## SIB 65 25 19

2020-11-09

### RECALL 19V-853: DRIVER'S FRONT AIR BAG (NADI) INFLATOR

This Service Information Bulletin (Revision 9) replaces SI B65 25 19 **dated October 2020**.

**EXAMPLE 2: Gas Generator Parts Label**

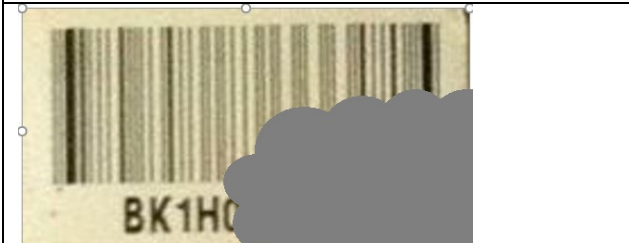
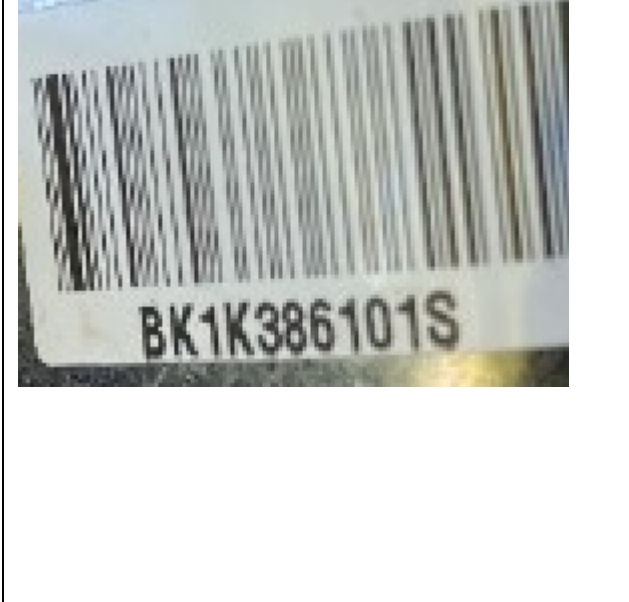
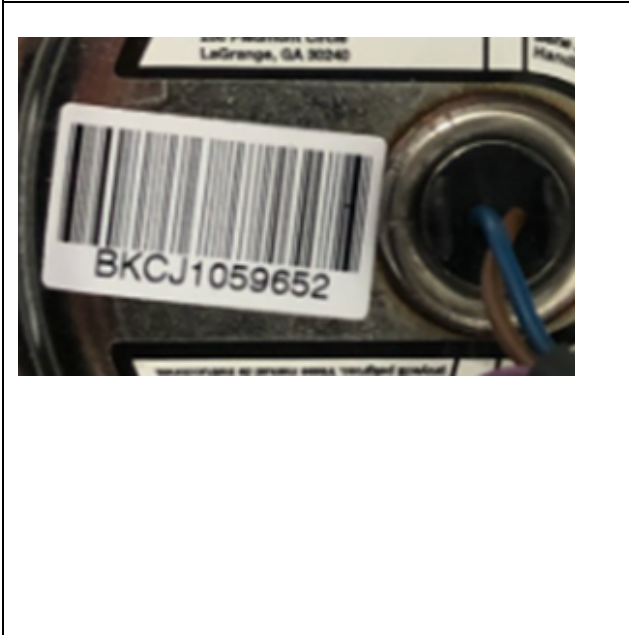
**BKCJ** may fall under two categories:

This example is **1059652** which is a higher serial number than 059659 so this is **Category 2**

**\*NOTE: The serial number can have 10 or 11 characters. Only the first 10 characters counted from the left are relevant for the check. The 11th digit can be disregarded for the repair covered by this SIB, so ignore the last digit 2**

**EXAMPLE 3: Gas Generator Parts Label**

**BK1K** may fall under two categories:

This example is 11 digits and **386101S** is above 088992 so this is **Category 3**

**\*NOTE: The serial number can have 10 or 11 characters. Only the first 10 characters counted from the left are relevant for the check. The 11th digit can be disregarded for the repair covered by this SIB, so ignore the letter S**

| Up to 059642 | <b>Category 1</b> – Drivers air bag gas generator must be replaced; the vehicle cannot be driven until repaired. |
| From 059659  | <b>Category 2</b> – Drivers air bag gas generator must be replaced   |

| Up to 088984 | <b>Category 2</b> – Drivers air bag gas generator must be replaced |
| From 088992  | <b>Category 3</b> – Drivers air bag gas generator is OK            |
